University of South Carolina
USC Baruch Marine Lab Mechanical HVAC Replacement
Project Number: CP00320788
Project Manager: Dwight Cathcart

Addendum Number One (1)

DATE: July 28, 2014

Drawing 1 – Taper Roof Plan (FOR REFERENCE ONLY)

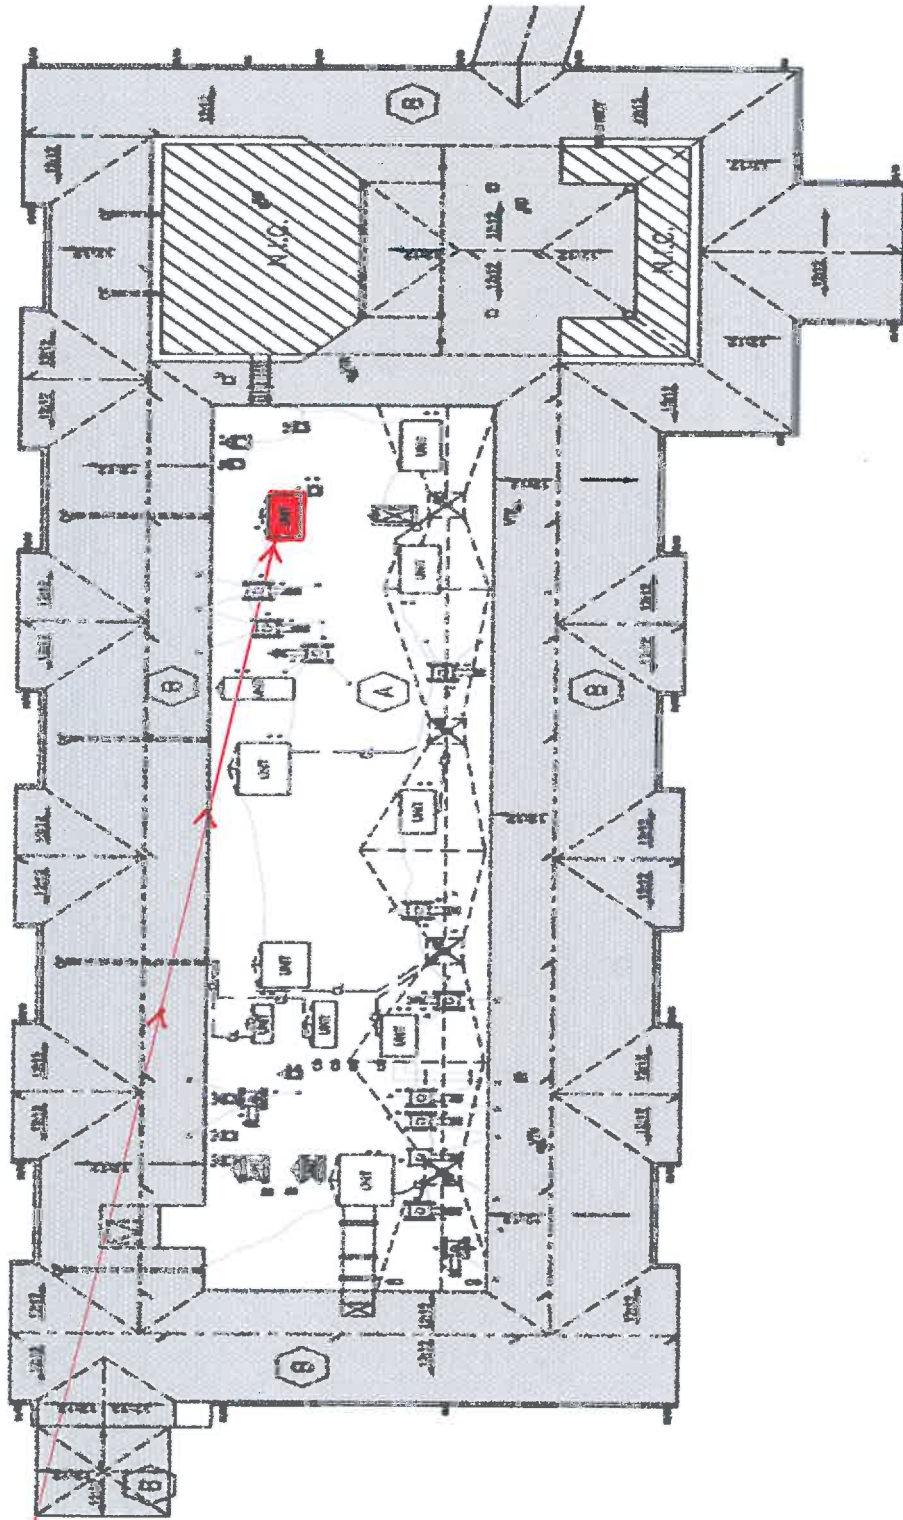
1. The identified location of the HVAC unit to be replaced is incorrect. Please see revised Project Manual identifying correct HVAC unit to be replaced including updated photos.
2. See also revised Drawing 1 dated July 28, 2014

- HVAC Unit to be Replaced
